Service Bulletin

Reinforcement Plate Installation on aircraft SB-LTUL-CTLS-13

Installation of Reinforcement Plate in upper attachment points of 4-point Harnesses.

Fig. 3-3-1-1 (View from luggage compartment)

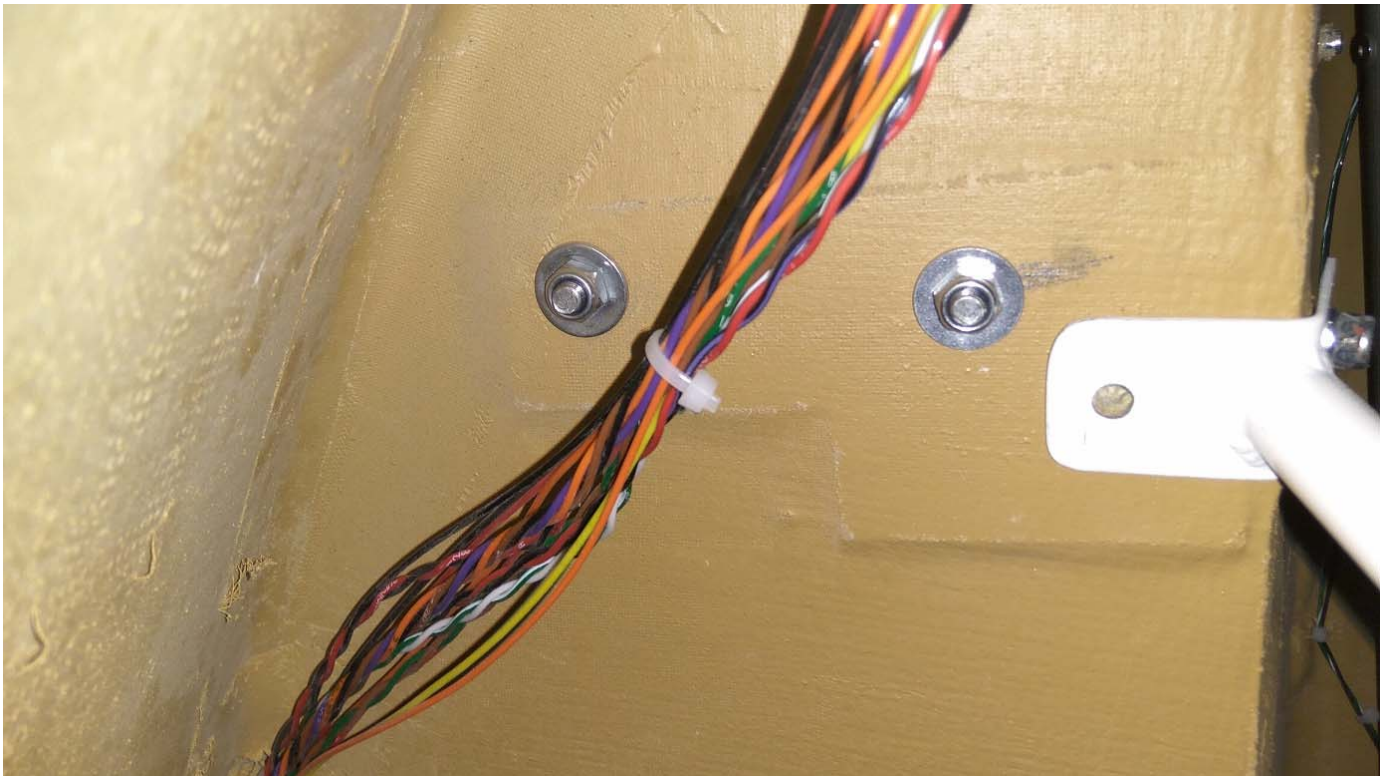
3.3.1 Uninstall upper attachment point of Pilot Safety Belts.

Fig. 3-3-2-1.

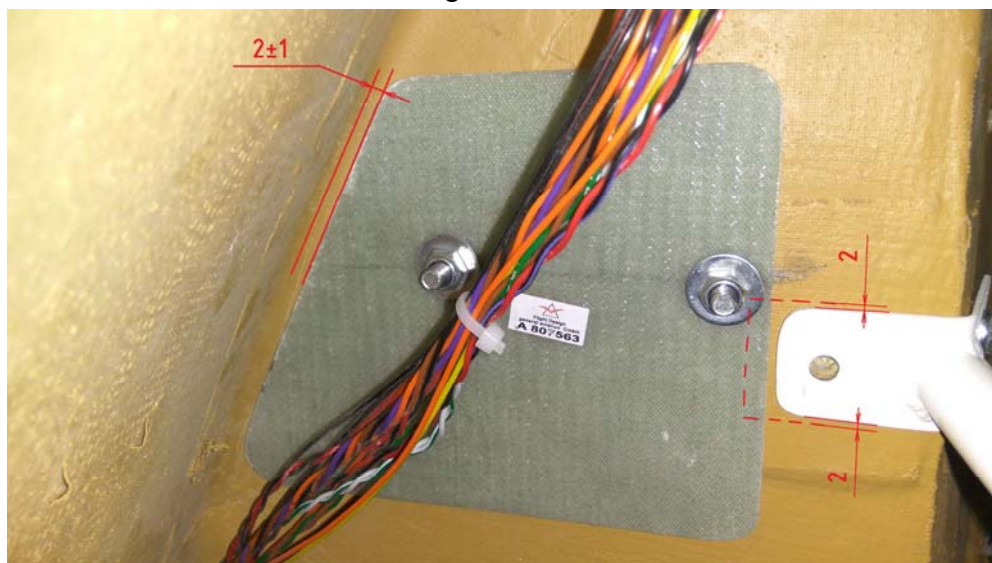
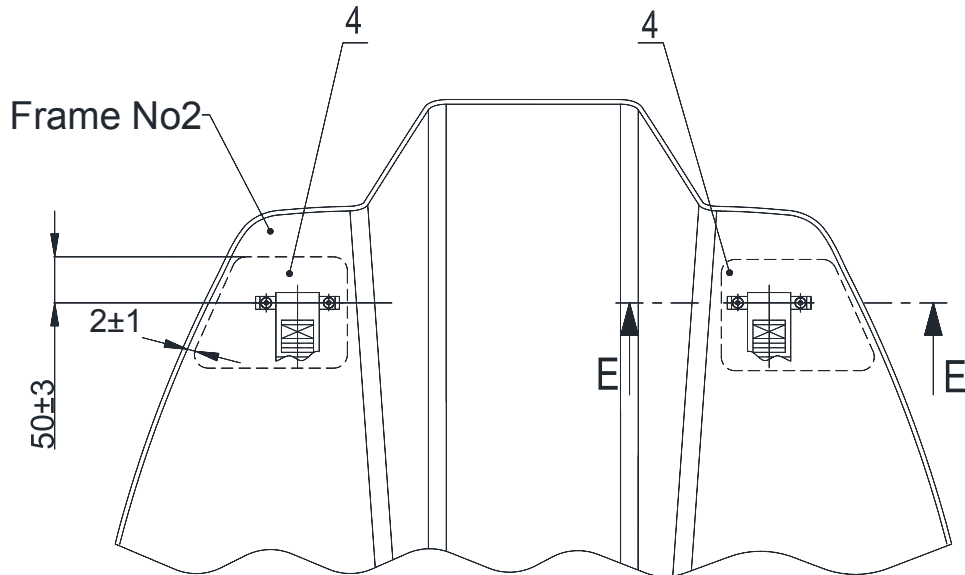
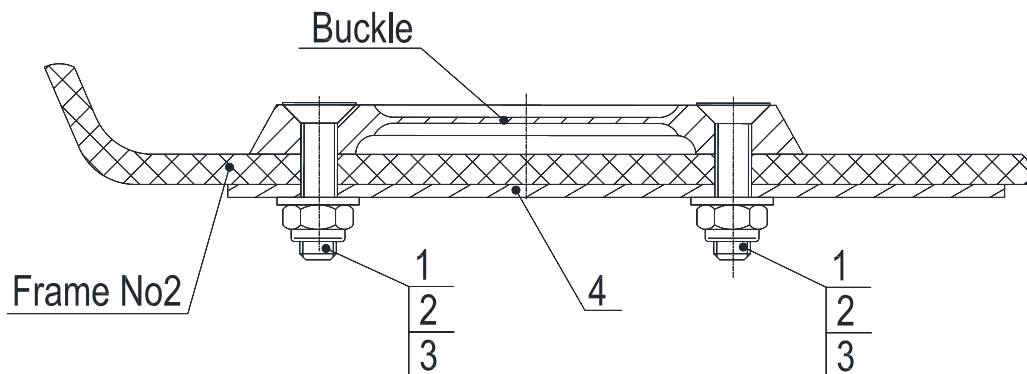
3.3.2 Install the Reinforcement Plate from baggage compartment side.

1. Position the plates according to the sketch on the frame. Mark the hole position. In case the plate overlaps with the parachute rescue system bracket attachment, mark and cut out a notch or trim the plate to give the correct placement. See Fig. 3-3-2-1.
2. Drill the 6 mm holes according to the markings.
3. Make a test installation and verify that the plate has correct position and a minimized gap to the frame.
4. Make final installation according to the Sketch 1.

Mark all bolt-nut connections with "Paint Maraflored TK 36 red" or equivalent torque stripe.

Tightening torque nuts: 9Nm.
